Access Compliance Report

Public Rights-of-Way

(Curb Ramps)

Intersection ID: 54217	Main Street: GOLF_LINKS_DR	Cross Street: MIDWAY_PARK_DR	Location: SW
ADA ID: F26C445B4A51	Ramp Type: Perp	Initial Pass/Fail: Fail	Overall Compliance: No
Severity Score: 12.5			
Codes/Mitigation Info/Possible Solution		Field Measurements/Component Compliance

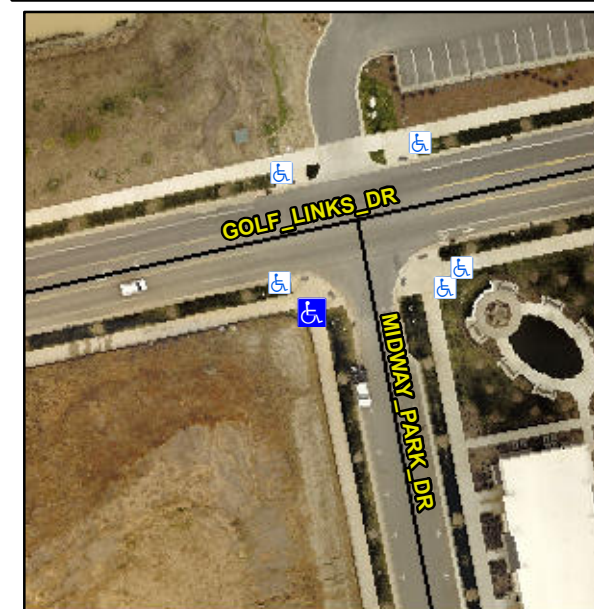
Not Found, R304.2.2

Compliance	Description	Data	Compliance	Description	Data
N/A	Ramp Length (in)	105.0	No	Ramp Slope (%)	8.7
Yes	Ramp Width (in)	52.0	Yes	Ramp XSlope (%)	1.1
N/A	Flare Type LT	N/A	N/A	Flare Type RT	N/A
N/A	Flare Slope LT (%)	N/A	N/A	Flare Slope RT (%)	N/A
N/A	Flare Traversable LT?	N/A	N/A	Flare Traversable RT?	N/A
N/A	Landing Length (in)	N/A	N/A	DWS Provided?	N/A
N/A	Landing Width (in)	N/A	N/A	DWS Contrast?	N/A
N/A	Landing Slope (%)	N/A	N/A	DWS Length (in)	N/A
N/A	Landing X Slope (%)	N/A	N/A	DWS Full Width?	N/A
N/A	Landing Curb? (Y/N)	N/A	N/A	DWS Offset (in)	N/A
N/A	Shared Landing?	N/A			
N/A	Gutter Ponding?	N/A	N/A	Gutter Slope (%)	N/A
N/A	Gutter Lip Ht (in)	N/A	N/A	Gutter X Slope (%)	N/A
N/A	Painted X Walk1?	No	N/A	Painted X Walk2?	N/A
	X Walk 1 Direction	To E		X Walk 2 Direction	N/A
N/A	X Walk 1 Width (in)	N/A	N/A	X Walk 2 Width (in)	N/A
	X Walk 1 Slope (%)	1.9		X Walk 2 Slope (%)	N/A
	X Walk 1 X Slope (%)	2.8		X Walk 2 X Slope (%)	N/A

Remove & Replace Entire Ramp.
